# Appendix A: Responses to expert's letter dated 22nd November 2024

## Summary of responses

This PDF document shows Beca replies (in blue) to the letter prepared by Mr Lines and Dr Hargraves dated 22nd November 2024. These responses should be read in conjunction with the text in the Statement of Reply of Dan Chamberose (27 November 2024) document under Section 5. SLOPE INSTABILITY SUSCEPTIBILITY OVERLAYS AND DEBRIS RUN-OUT OVERLAY – ACCURACY OF THE OVERLAYS.

Figure A-18 Above Brunner Street (Grampians)

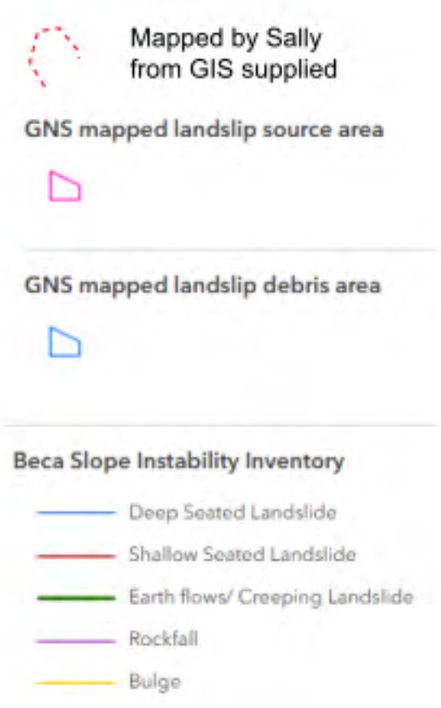
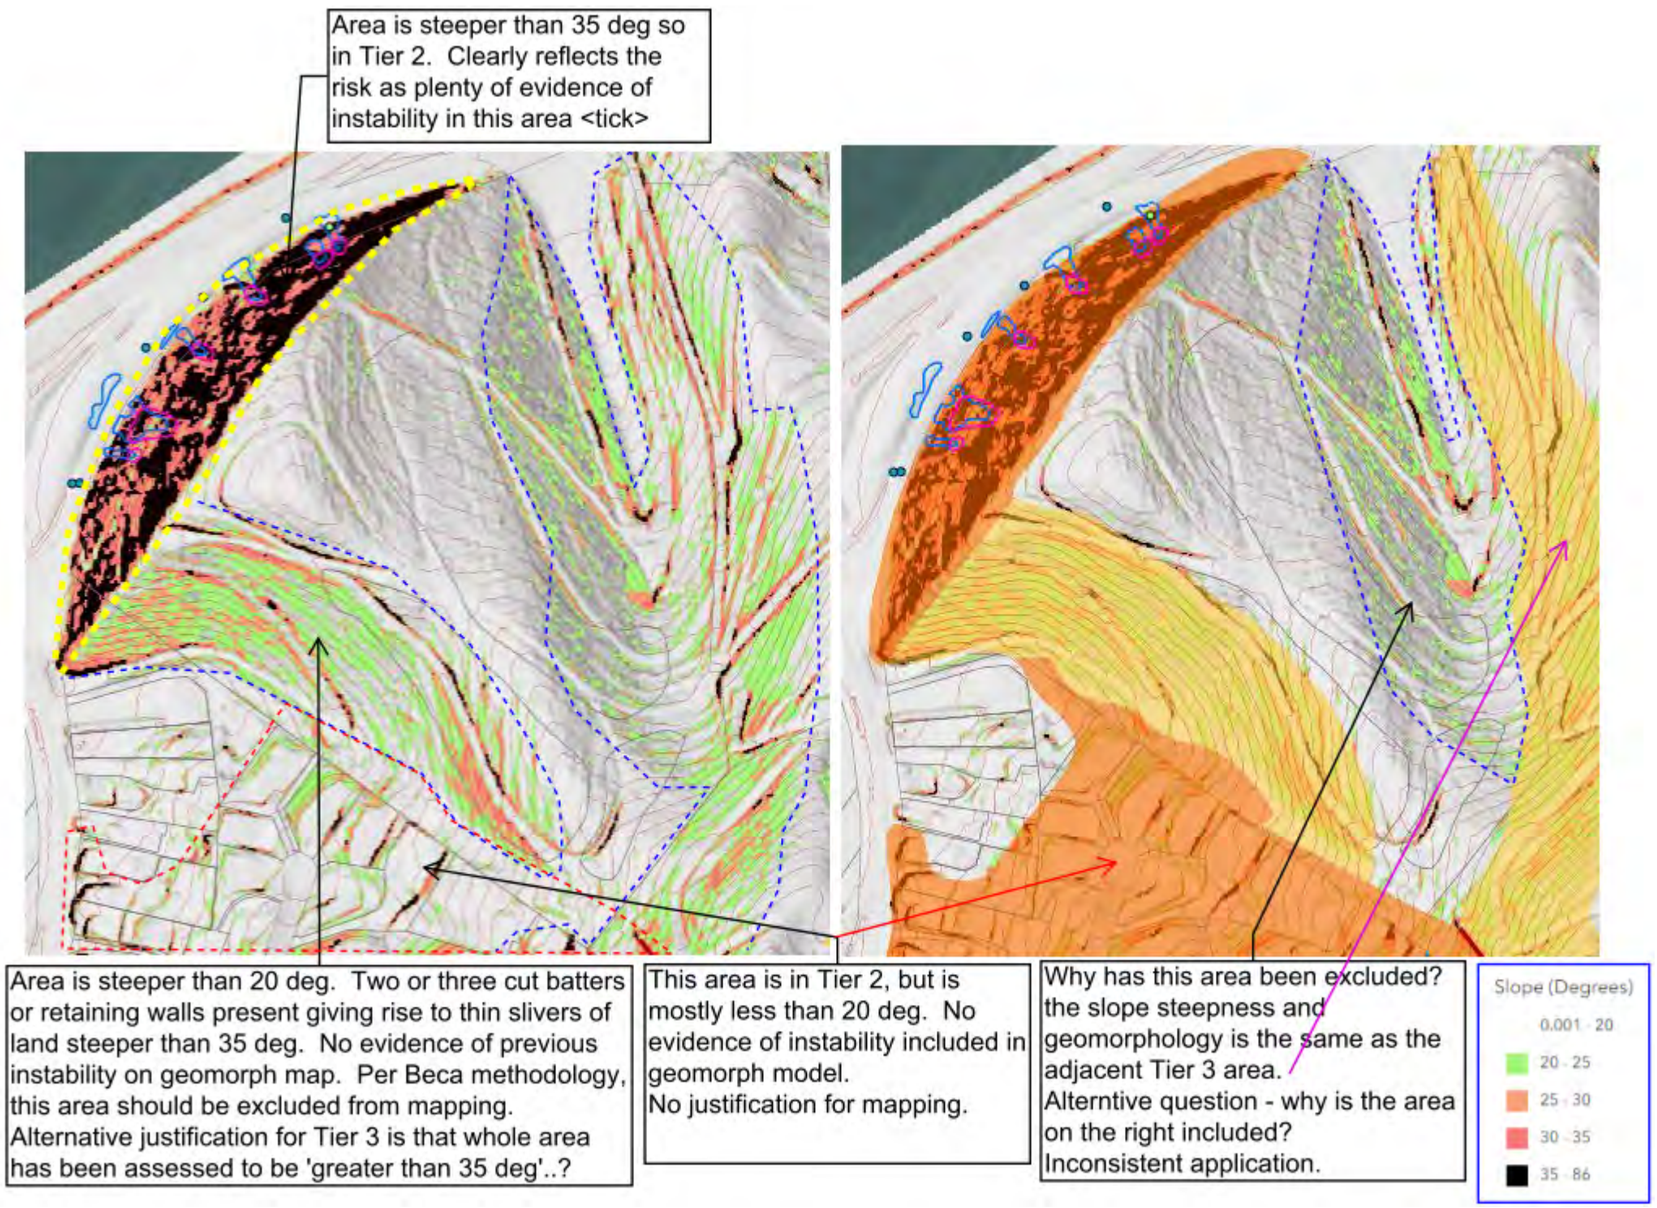
| A18 | Above Brunner Street (Grampians) | Absence of detailed mapping of geomorphic features in Beca inventory in an area assigned as Tier III that exhibits widespread evidence for slope failures in the DEM. | In this particular area, due to the amount of instability present on the slope, each individual feature was not identified as it is clear this whole area has stability issues. The slope instability inventory has been created in accordance with the AGS guidance and aligns with a 'basic' level inventory. The mapping of features is not considered to be an exhaustive record of all instability in the region but is sufficient to show the classification and distribution of slope instability on hillslopes in the region. The aim of the mapping was to capture a representation of slope failure locations and types in the region. In my opinion, this type of inventory, in combination with the other evidence of slope instability (i.e. records provided by NCC and the Post-August 2022 landslide dataset provided by GNS) is sufficient to inform the creation of these slope overlays and aligns with the AGS guidance.<br><br>Features/areas identified by the experts are within the extents of the overlay, therefore no change is required.<br><br>Note: Some of this area is outside of PC29 extents. | Area already within overlay, no updates required. |

In this particular area, due to the amount of instability present on the slope, each individual feature was not identified as it is clear this whole area has stability issues. The slope instability inventory has been created in accordance with the AGS guidance and aligns with a ‘basic’ level inventory. The mapping of features is not considered to be an exhaustive record of all instability in the region but is sufficient to show the classification and distribution of slope instability on hillslopes in the region. The aim of the mapping was to capture a representation of slope failure locations and types in the region. In my opinion, this type of inventory, in combination with the other evidence of slope instability (i.e. records provided by NCC and the Post-August 2022 landslide dataset provided by GNS) is sufficient to inform the creation of these slope overlays and aligns with the AGS guidance.

Features/areas identified by the experts are within the extents of the overlay, therefore no change is required.

A20 - Marie Place, Bishopdale

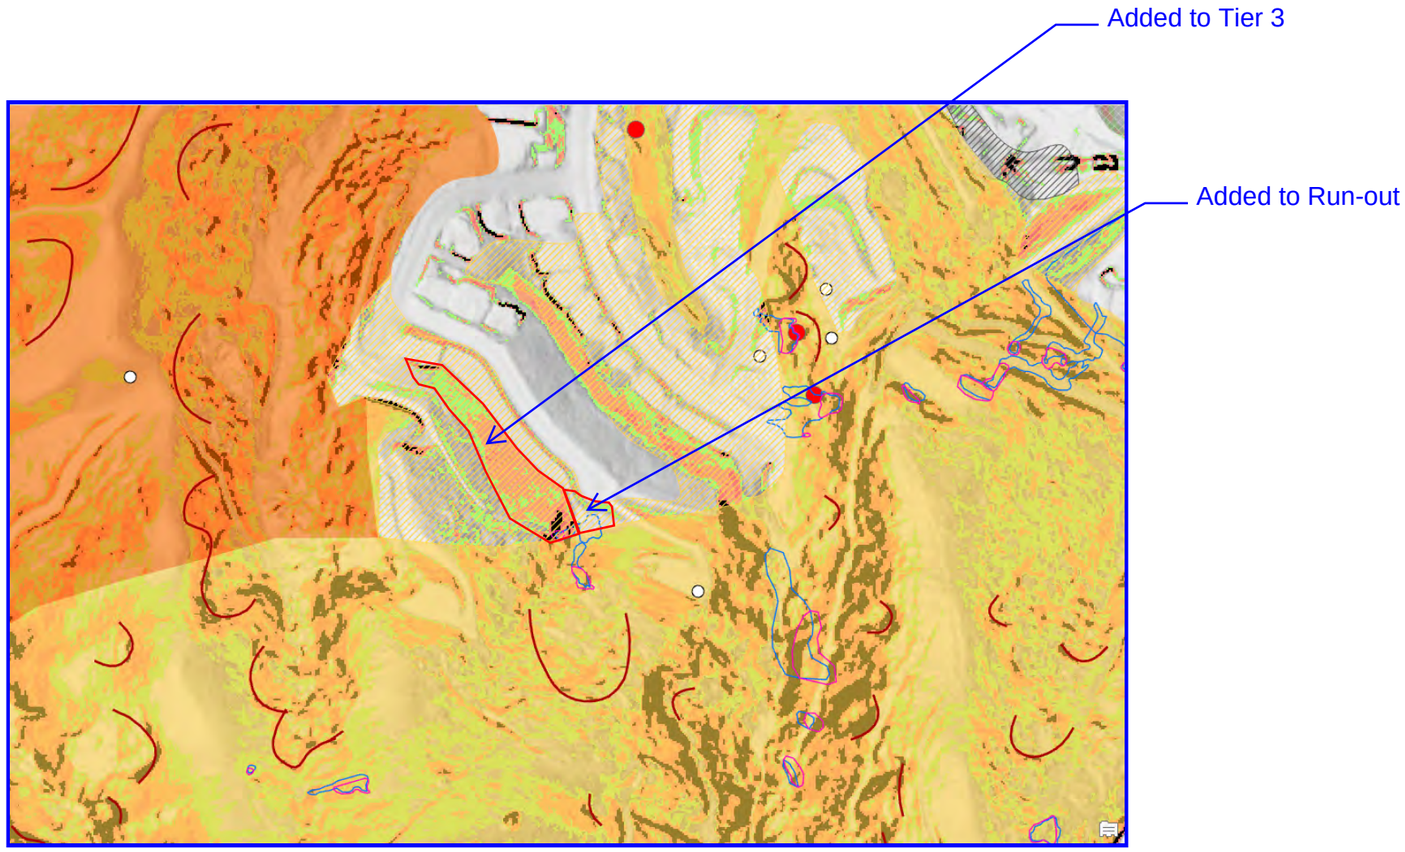
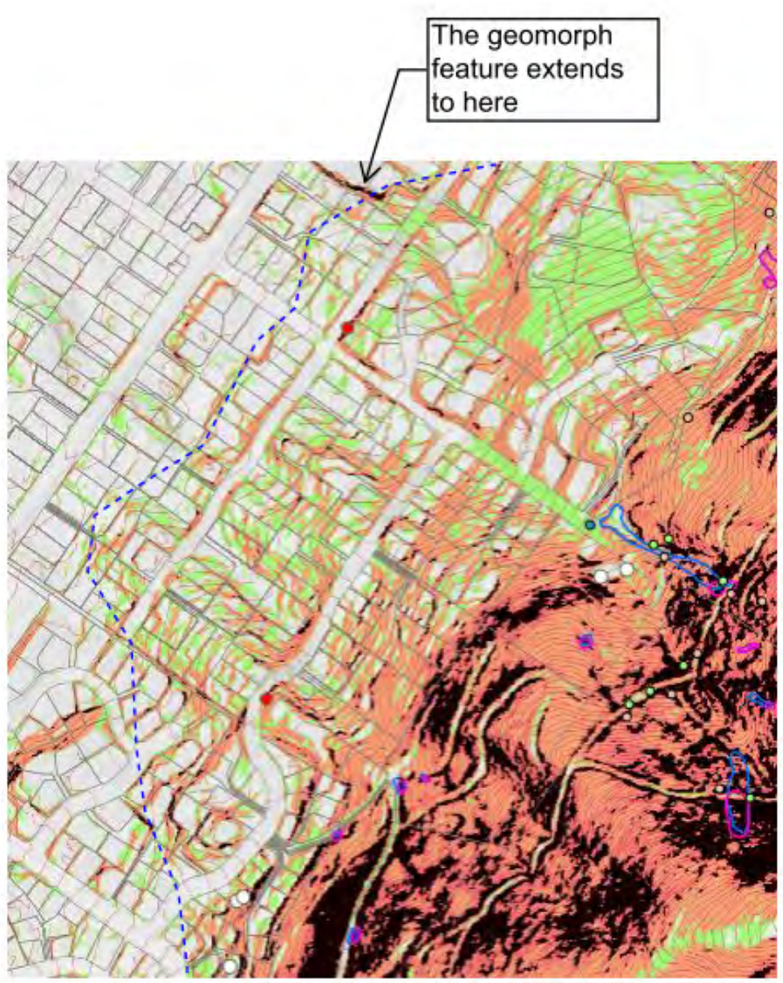
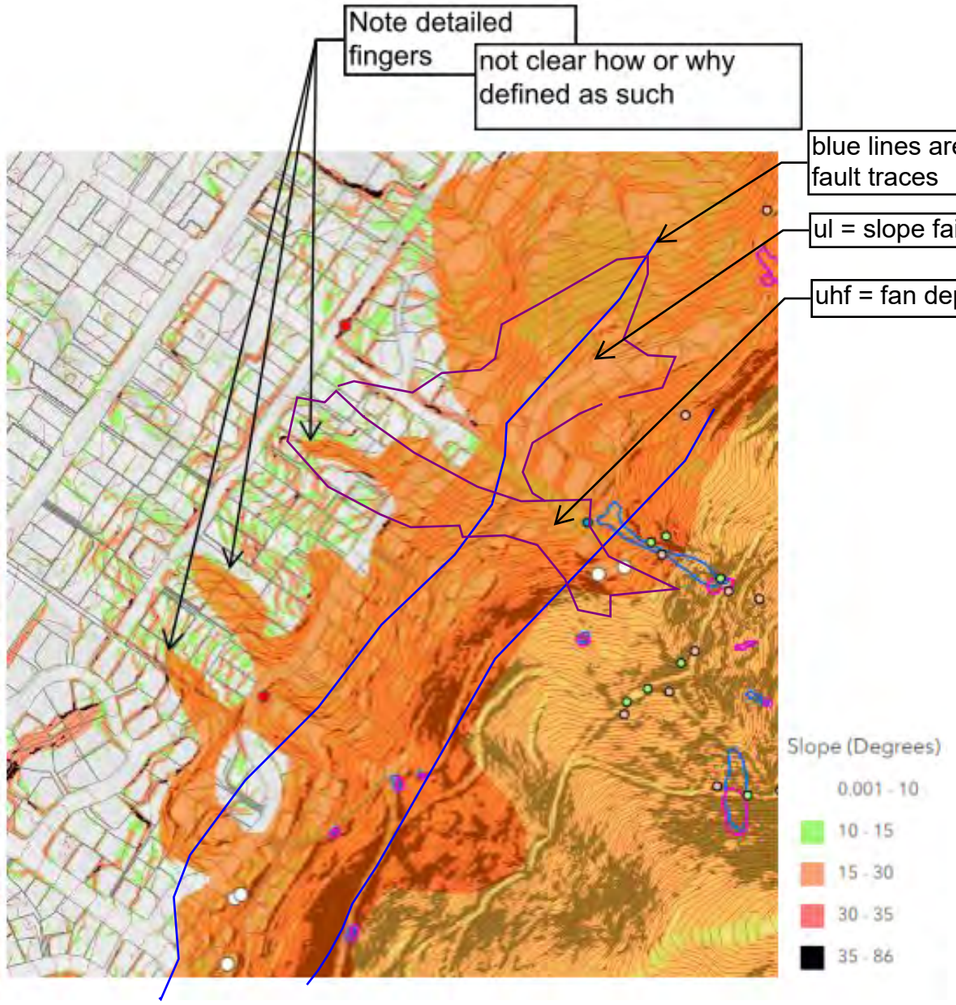
| A20 | Marie Place, Bishopdale | Area with geomorphic evidence of previously being impacted by a slope failure in the DEM and containing mapped inundation in the post-August 2022 mapping by GNS is excluded from Tier III along with adjacent slope. | I agree that this small area should be included in the overlay and a small area as run-out (see snip for proposed extents) | Update Tier III boundary to incorporate area and also run out below. Revised area is not outside the original Beca (2023) overlay extents |

**A20 Response**
I agree that this small area should be included in the overlay and a small area as run-out (see snip for proposed extents)

A21 - Brunner / Tukuka Streets, Nelson South

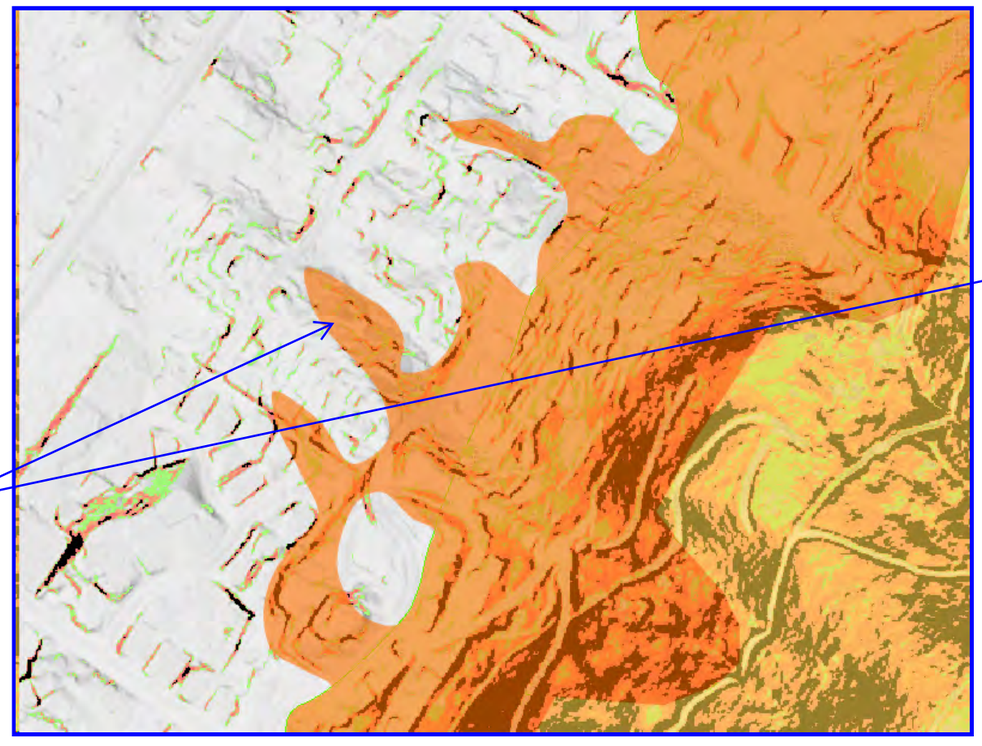
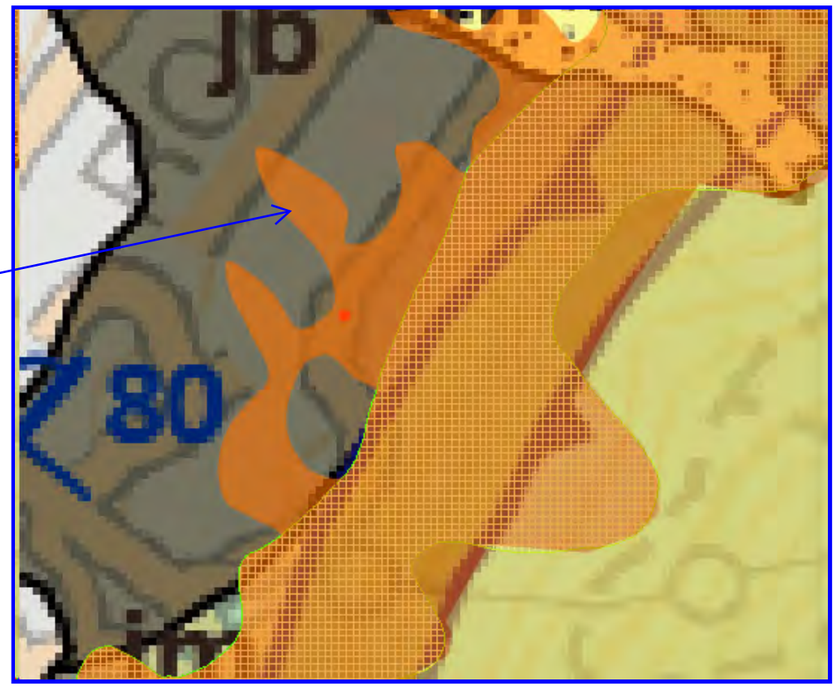
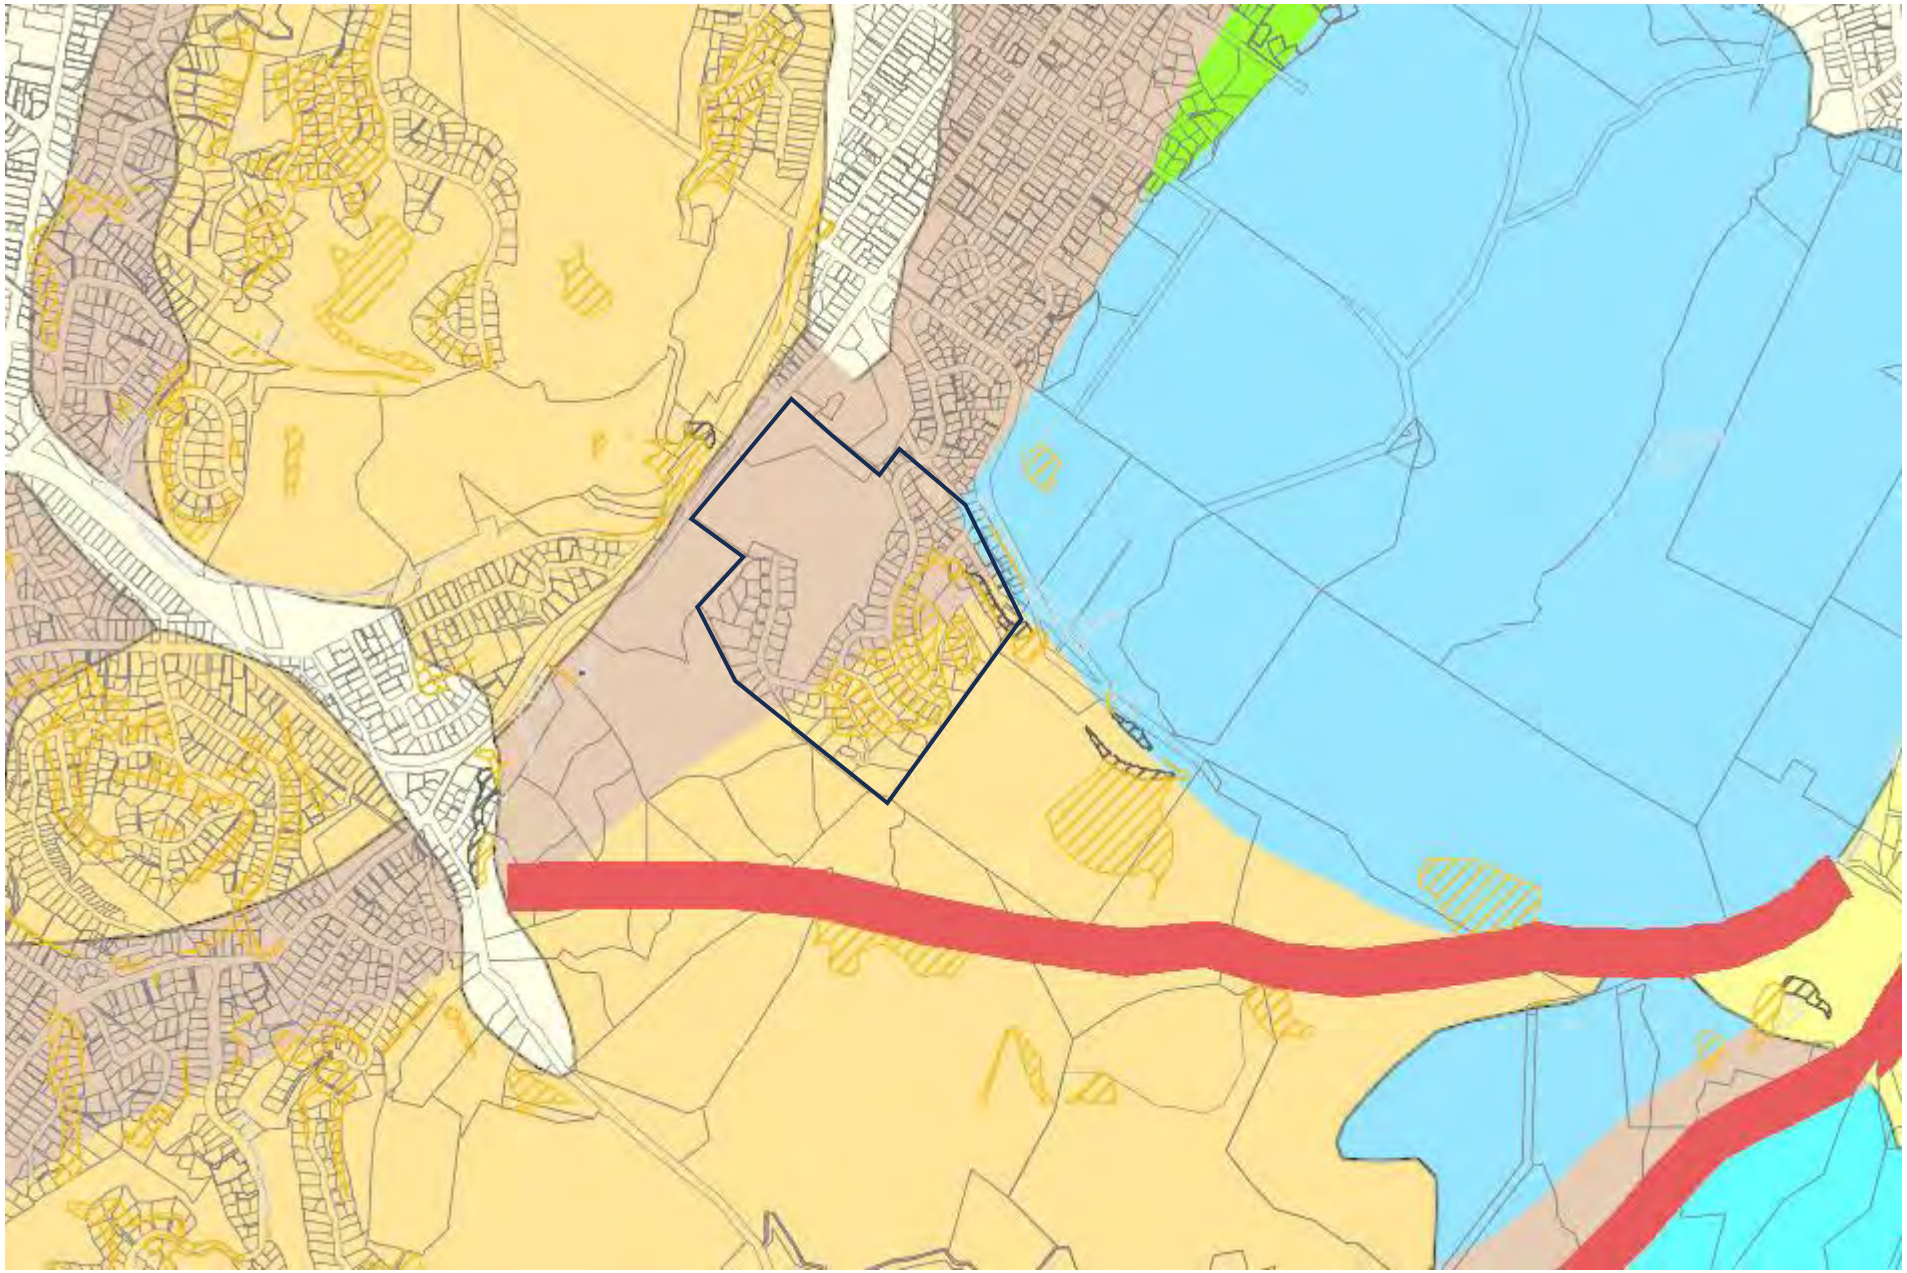
No geomorphic features have been identified so it's not clear why this area has been designated as Tier 2, nor is it clear why the edge is defined as it is. The same 20 to 35 degrees slopes extend out to the blue dashed line, but the edge of the Tier 2 zone is interfingered out into this area. The geology maps seem to indicate there may be old slope failure deposits in this area, but the areas don't match those used in the mapping.

The overlay in this area was based on the original Grampians overlay with geomorphic mapping identifying that the landslide feature extends further downslope than the area within the Grampians Overlay. The downslope area exhibiting hummocky topography and >20 degrees was included in the original map resulting in the 'fingers'. The remaining area <20 degrees was excluded. This overlay was subsequently subdivided into the Tier II area and therefore inherited the morphology from the original overlay at the request of the SI-TAG. (See snip for interpretation). As this area was within the Grampians overlay already, geomorphic evidence of deep seated features were not mapped.

The geomorphology of the slope indicates the feature extends downslope further than identified in the original Grampians overlay, as represented by blue dashed line in figure provided by experts. The original assessment identified the downslope extents of the feature that were <20 degrees, resulting in the 'fingers' with downslope area excluded. These extents subsequently informed where Tier II was identified as the overlay was subdivided.
